TOWN OF GOLDEN BEACH

Official Agenda for the November 17, 2026
Regular Town Council Meeting called for 6:00 P.M.

6. **A Resolution of the Town Council Authorizing and Approving Rolling Change Orders to the Contract with John Bell Construction, Inc. for the Town Wellness Center Project.**

A RESOLUTION OF THE TOWN COUNCIL OF THE TOWN OF GOLDEN BEACH, FLORIDA, APPROVING ROLLING CHANGE ORDERS TO THE WELLNESS CENTER CONSTRUCTION AGREEMENT WITH JOHN BELL CONSTRUCTION, INC. FOR THE TOWN WELLNESS CENTER PROJECT; PROVIDING FOR CONDITIONS; PROVIDING FOR IMPLEMENTATION AND AN EFFECTIVE DATE.

Attachments
Stairs Lighting Markup.pdf

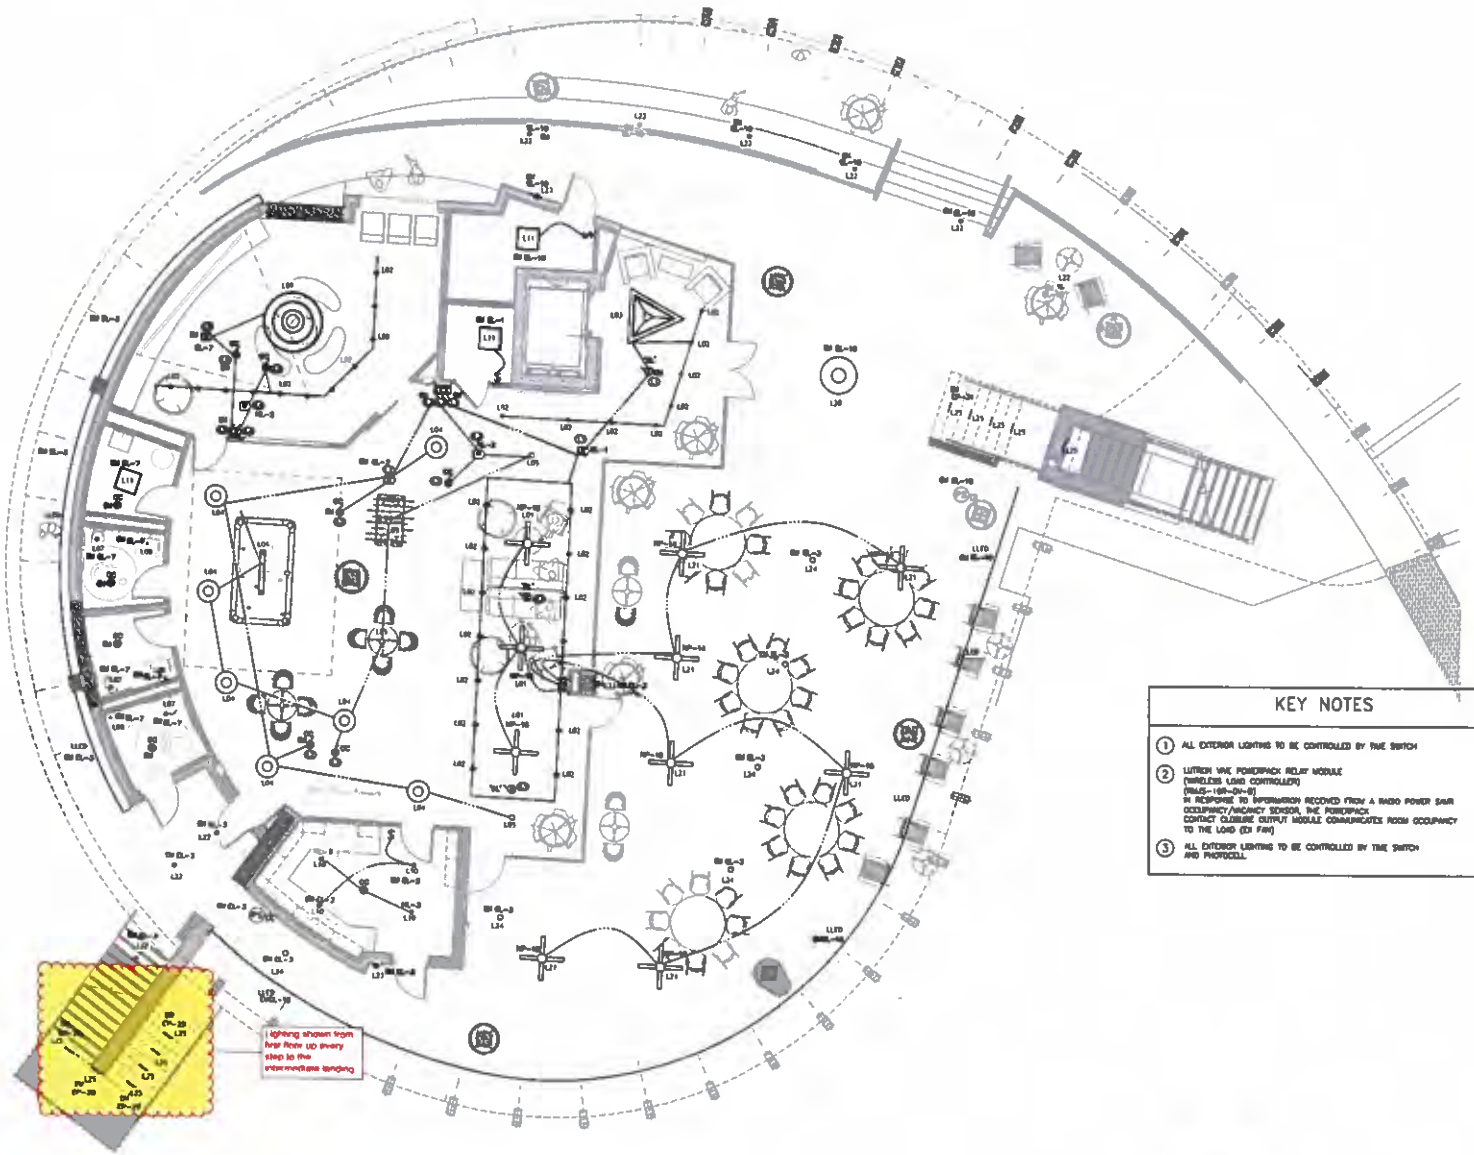
Ahsan, thank you for your response.
Please confirm if the other stairs also require lighting. See attached clouded areas.

RFI #025 Second Floor Staircase Lighting Response

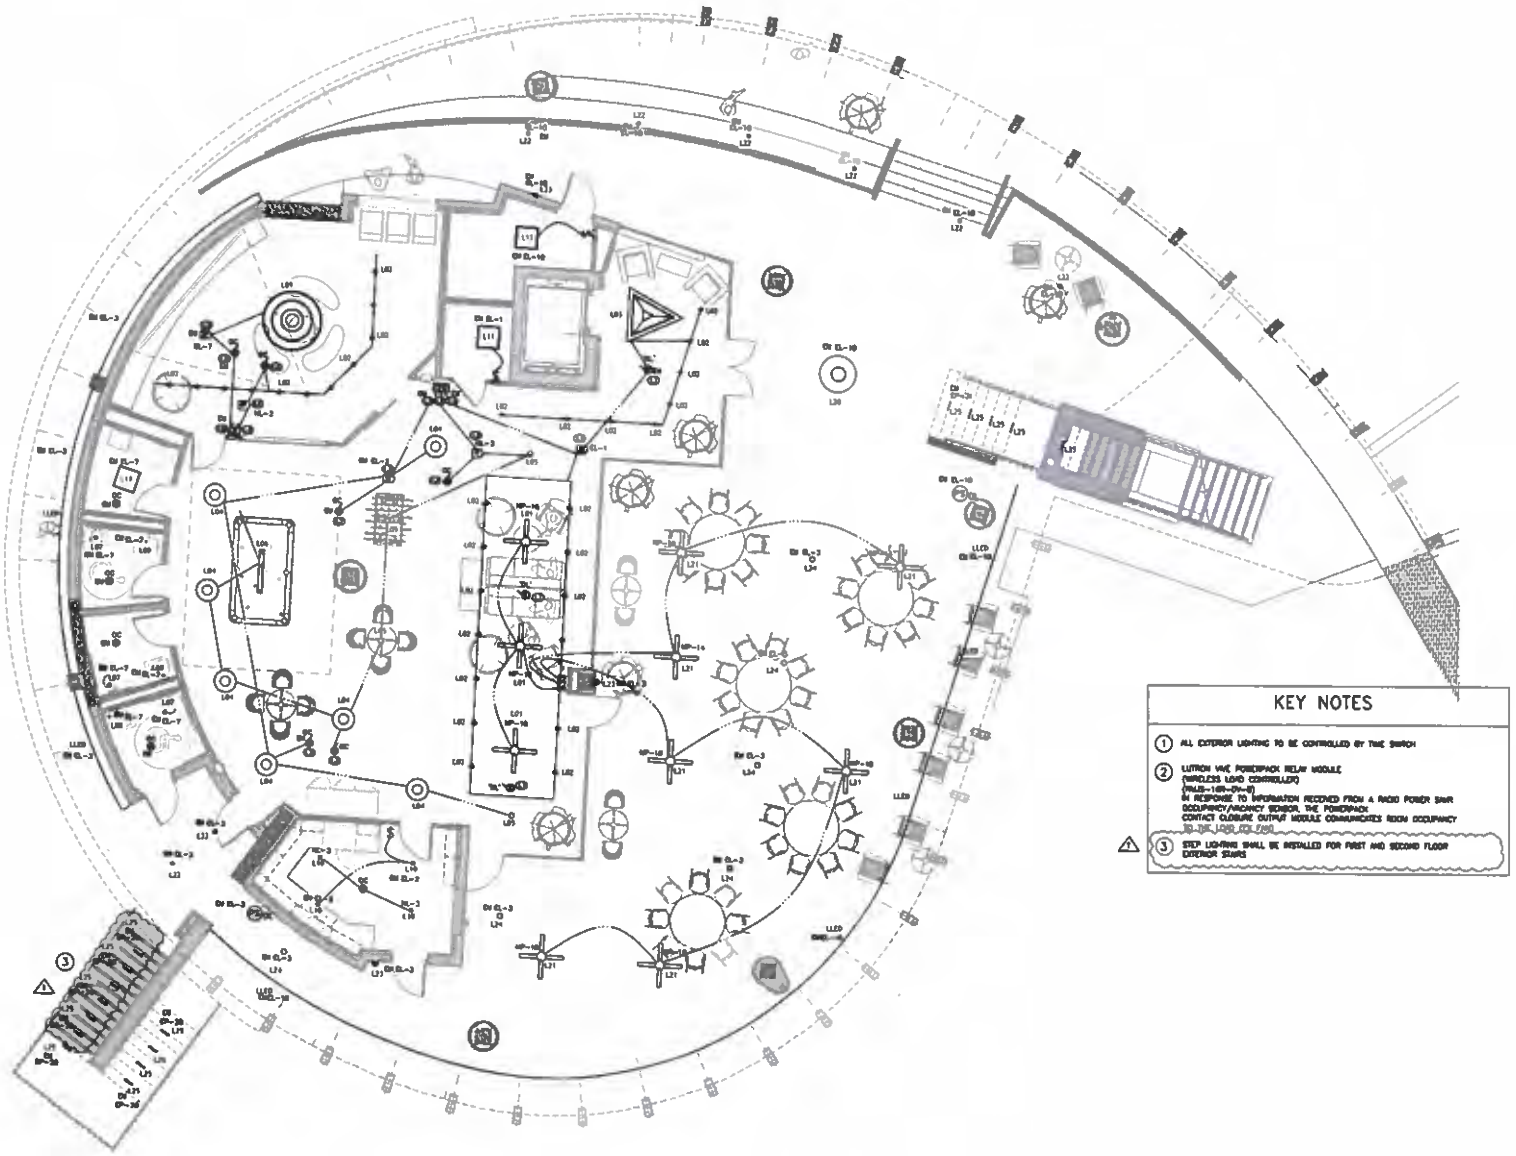
Staircase lighting should be on alternating treads the entire length of both primary stairways. This is shown on drawing 1/A202, 1/A305, and on 3/A304.

Drawing E-500 was updated and staircase lighting added from 2nd floor to 1st floor

Photo 1. Electrical Site Plan E-001. Revision 5.

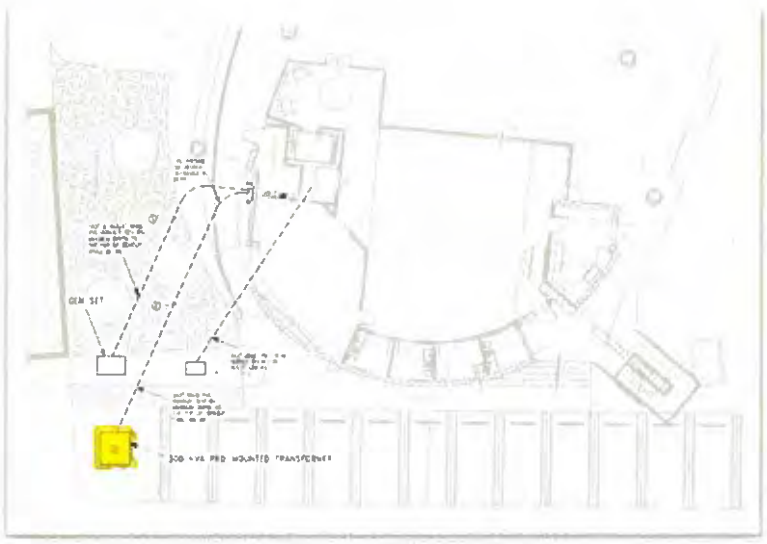
As a result of the revised location of the Florida Power & Light Company (FPL) transformer designated to serve the project, as shown on Electrical Site Plan E-001, the electrical feeder routing increased by approximately fifty (50) additional linear feet. Photos 1 and 2 illustrate the last revision plan (Revision 5) and the previous revision (Revision 4) respectively, clearly showing the difference in feeder routing distances. This change was not anticipated in the original contract documents and requires additional labor and materials beyond the original scope of work. Accordingly, this condition warrants a Change Order.

Photo 3. Electrical 2nd Floor – E101. Revision 4.

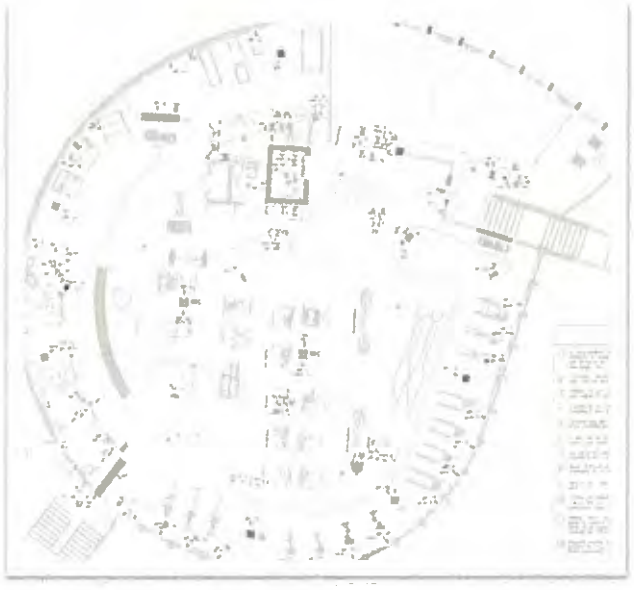
➢ As a result of the newly added junction boxes for the motorized curtains, as indicated on the Electrical 2nd Floor in the most recent plan revision (Revision 4), additional labor and materials not included in the original contract scope are required, thereby warranting a Change Order.

DETAIL 1/S102R

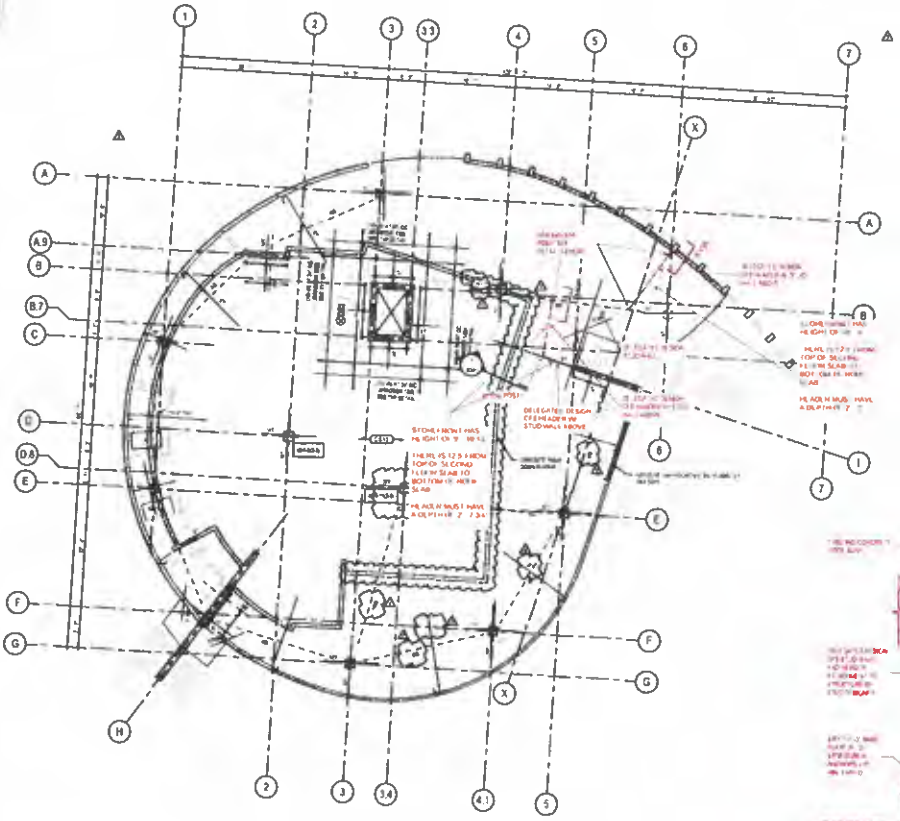
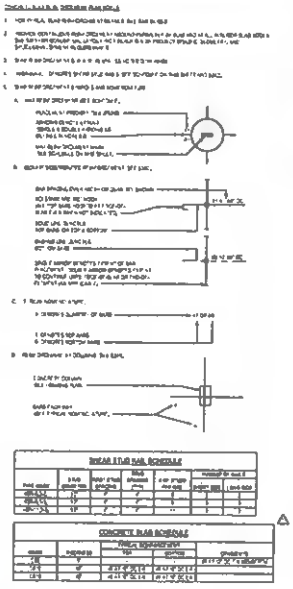
The exterior wall shown on Sheet A113 does not have an identified wall type, and this wall is not shown or referenced on the structural drawings (Sheets S102 and S102R). Please confirm the intended wall type, including framing/material requirements, and provide the associated structural design and details for this wall.

Refer to attached sheet S102R for framing.

The exterior wall clouded on Sheet A113 is intended to be a light-gauge structural steel framed wall with tube steel reinforcement as required.
The Structural Engineer will provide the locations and sizing of any required tube steel columns associated with the primary structural system.

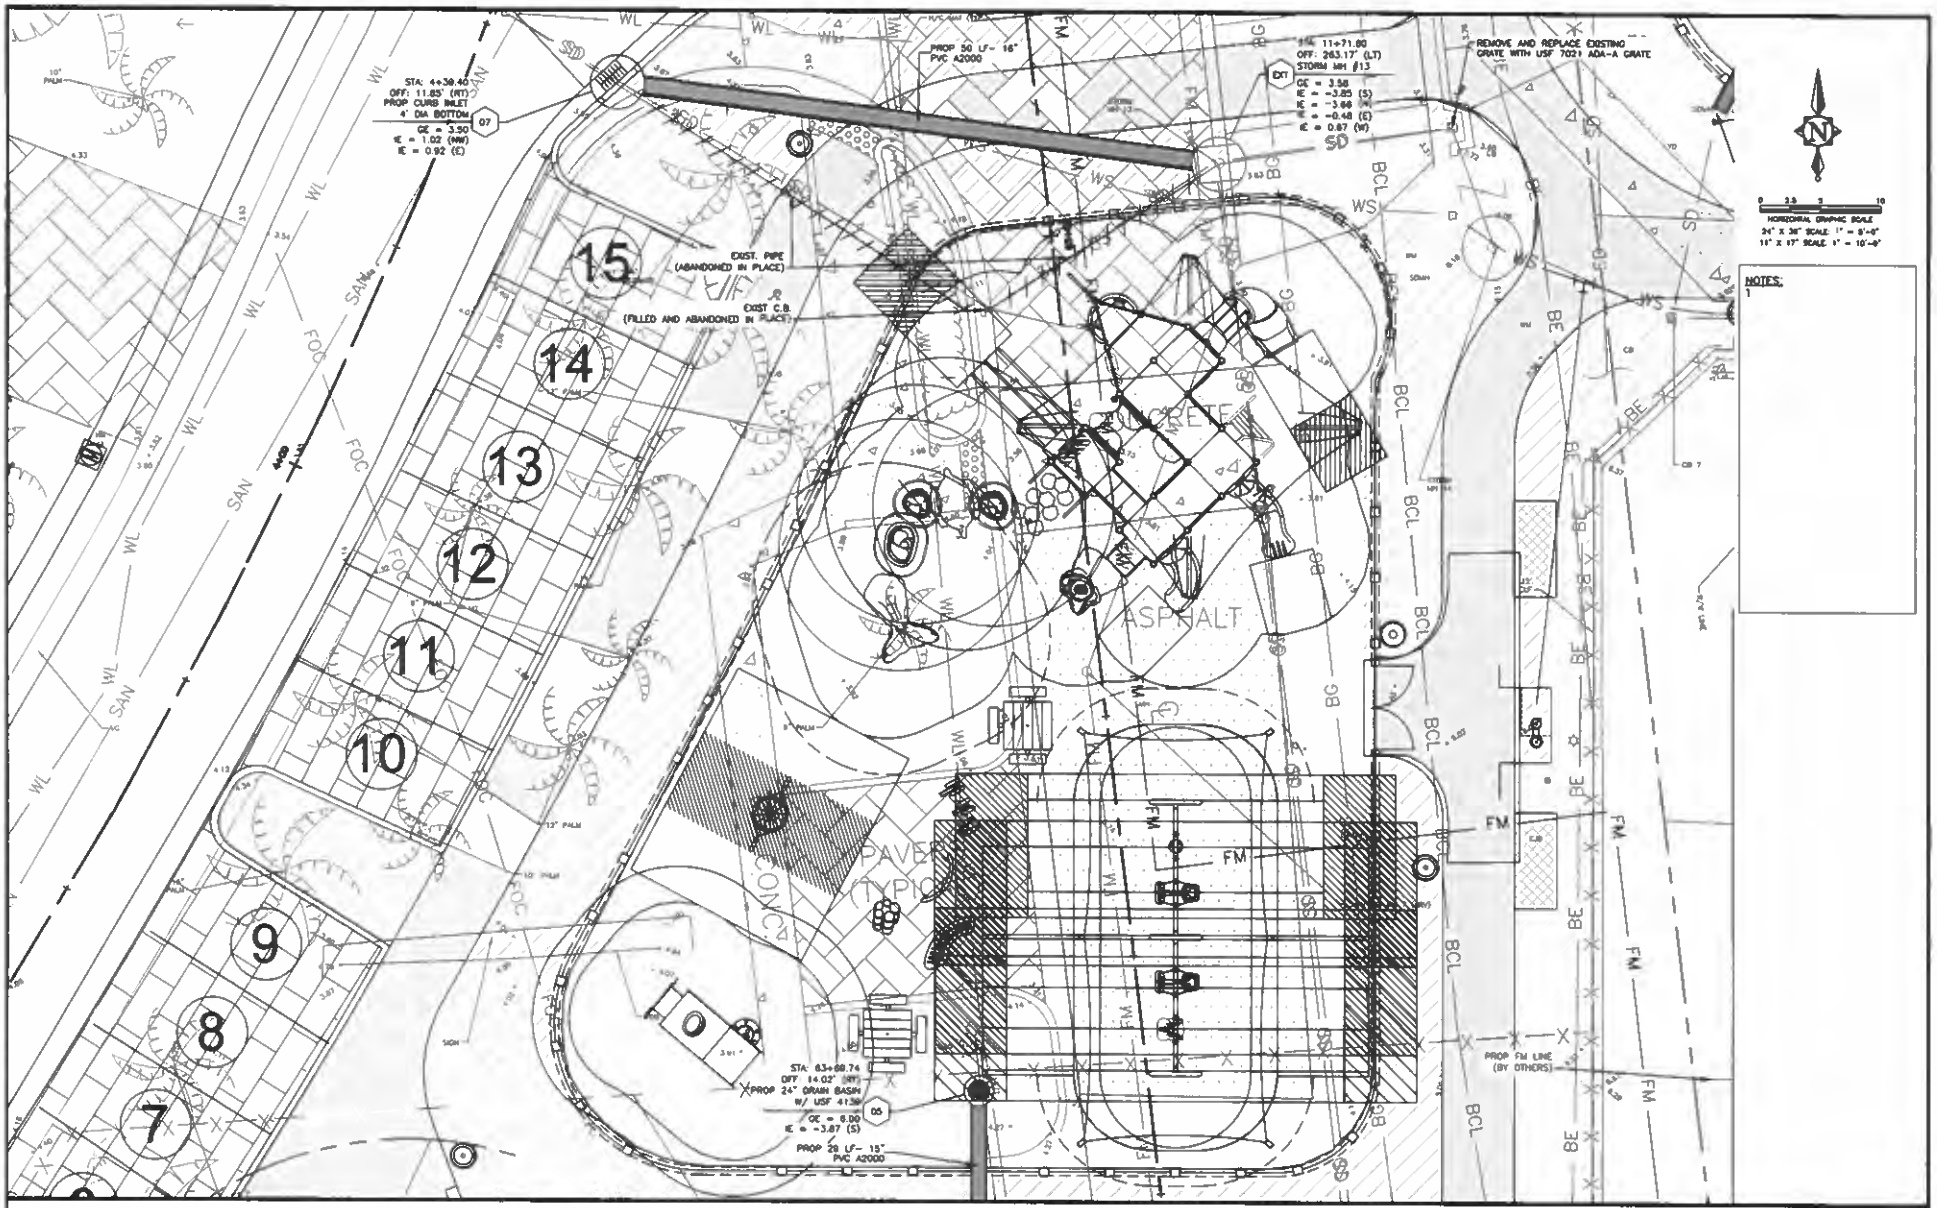
The attached is what I am recommending to avoid the conflict of the existing drainage structure and future play equipment. Please review for pricing to the Town? Please disregard the earlier version sent this morning, it had an incorrect invert.

Photo 1: Riser Diagram – Transformers T1 and T2 – Unprotected Panels NP and EP clouded in red.

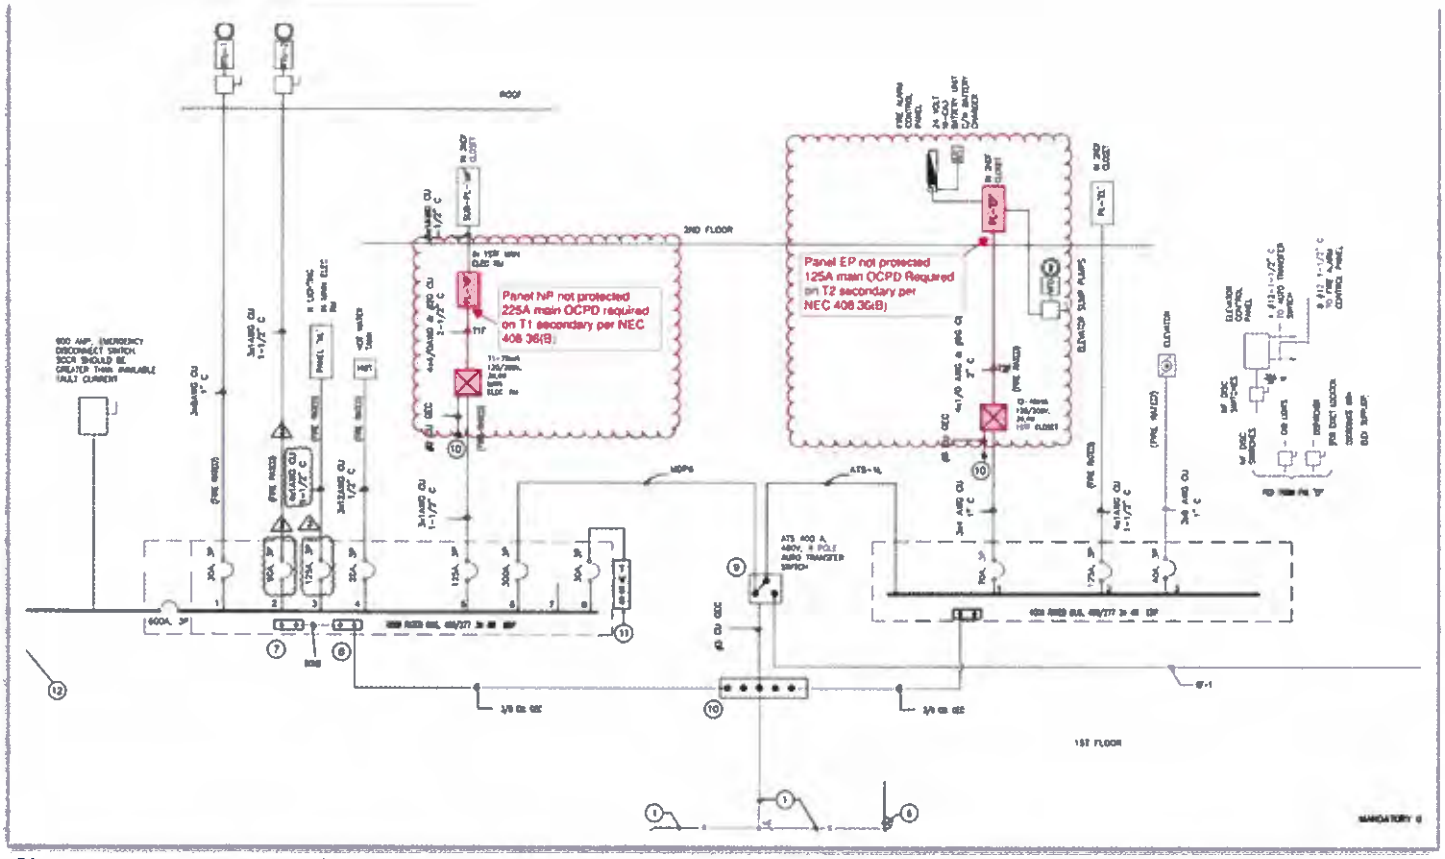
For the 45 kVA transformer serving the 125A EP Panel, provide a 125A main overcurrent protective device at the EP Panel or in a separate secondary side disconnect enclosure. For the 75 kVA transformer serving the 225A NP Panel, provide a 225A main overcurrent protective device at the NP Panel or in a separate secondary side disconnect enclosure."

Below is an excerpt from the electrical drawings showing that main circuit breakers were not included for Panels EP and NP, for reference and clarification of the additional work required.

Figure 1: E601 - Branch Panel: HS

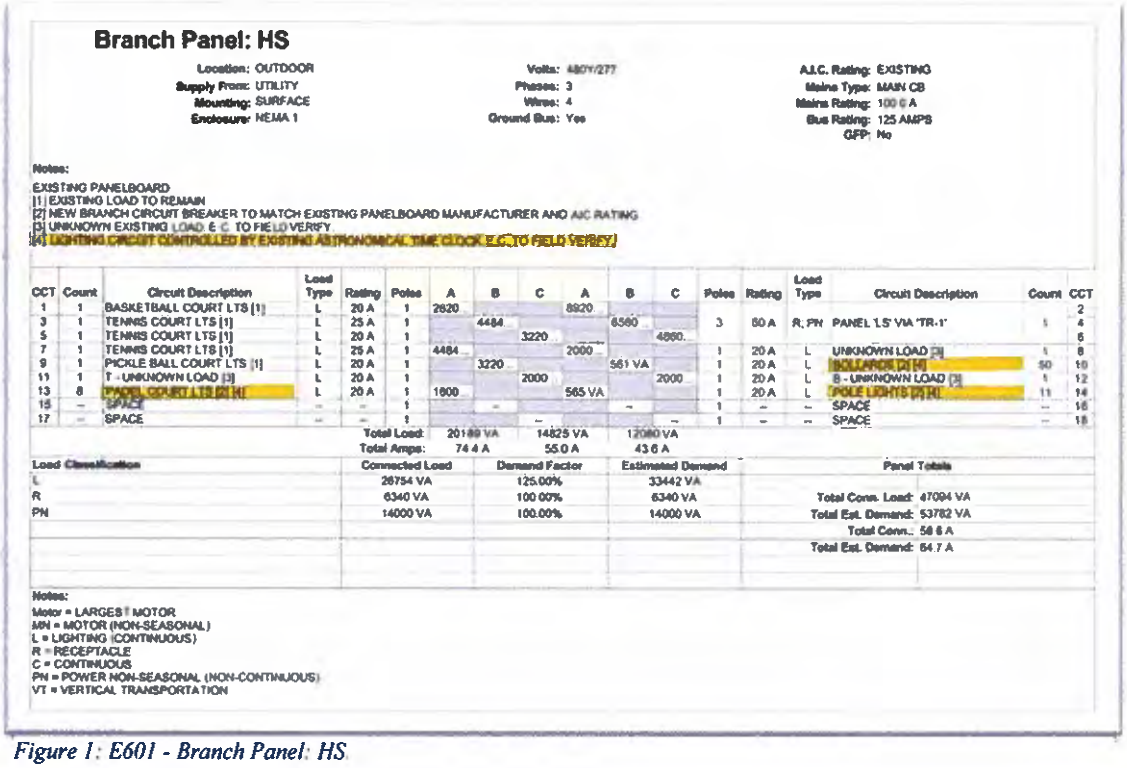
Below are the notes shown on the original contract drawings indicating the lighting control requirements, for reference and better understanding of the proposed work.

Photo 1 - E-001 - Approximate Underground Conduit Routes

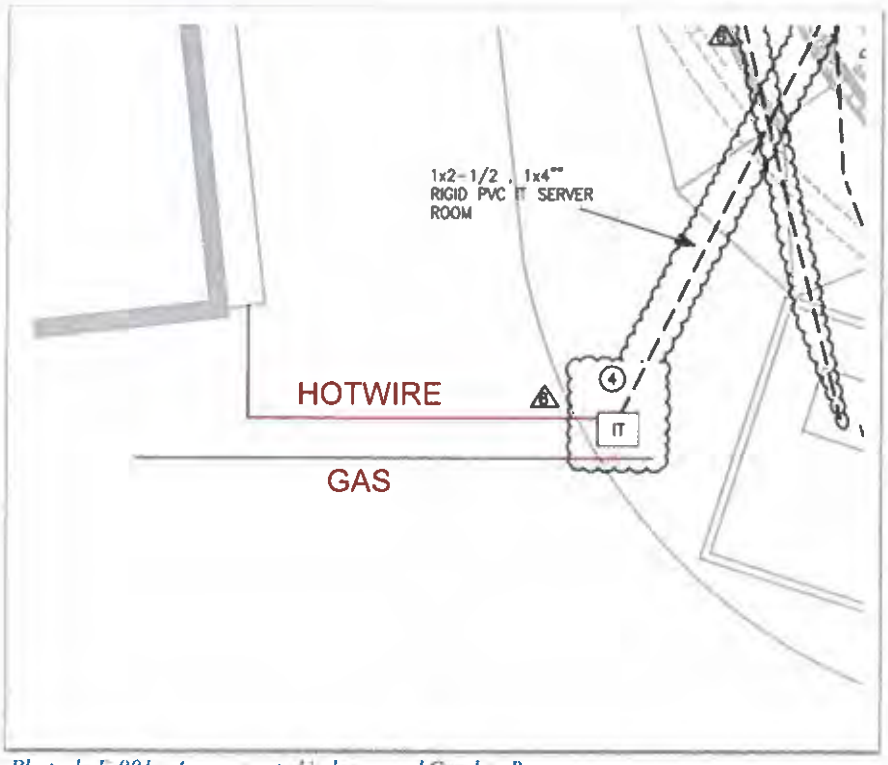
Below is a marked plan showing the approximate conduit routes and locations for reference and clarification of the additional work required.
